PCN Report

Prepared By : Maggie Xu, Thyristor Product Engineer
Date : July 3rd, 2018
Products : Thyristor Products acquired from ON Semiconductor
Revision : B

This report covers manufacturing site transfer activities of Thyristor products acquired from ON Semiconductor. Site transfer includes backend assembly, final test and packaging operations.

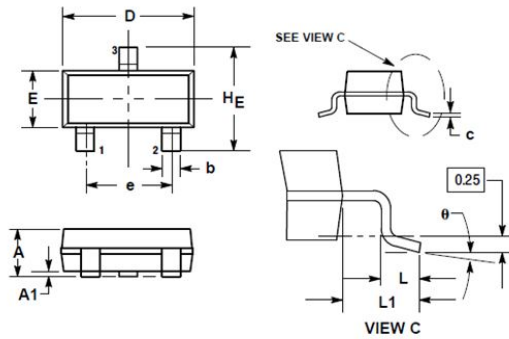
Format of Date code section of component marking is changed as follows.

4.2 SOT223 Outline

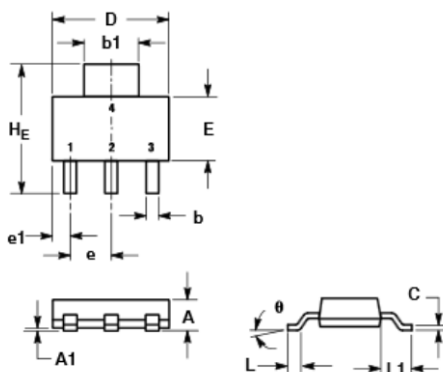
---Dimensions A, A1, c, D, e1 are different.
